BOARD OF ZONING APPEALS DIVISION I

Case Number: 2025-DV1-017

Property Address: 1421 East Michigan Street (approximate address)

Variance of Development Standards of the Consolidated Zoning and Subdivision Ordinance to provide for subdivision of a lot for construction of a

2025DV1017; Site Plan (with proposed subdivision; filed as 2025PLT010)

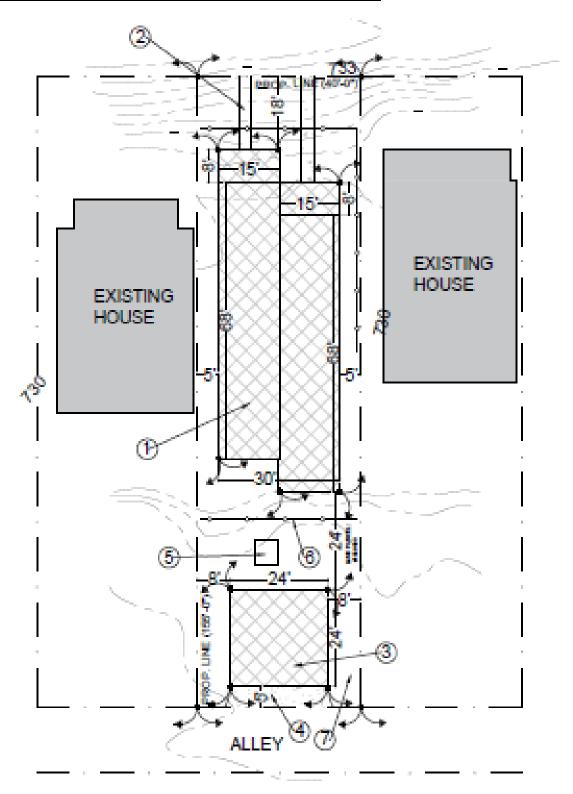
were issued. The plans submitted for this variance show a building with the same dimensions but with a 2.2-foot western setback and 7.8-foot eastern setback. It appears that the building was constructed in a location approximately 3 feet to the west of what had been proposed.

(Note: previous detached garage remains at site despite above plan indicating a rear yard 'concrete slab')
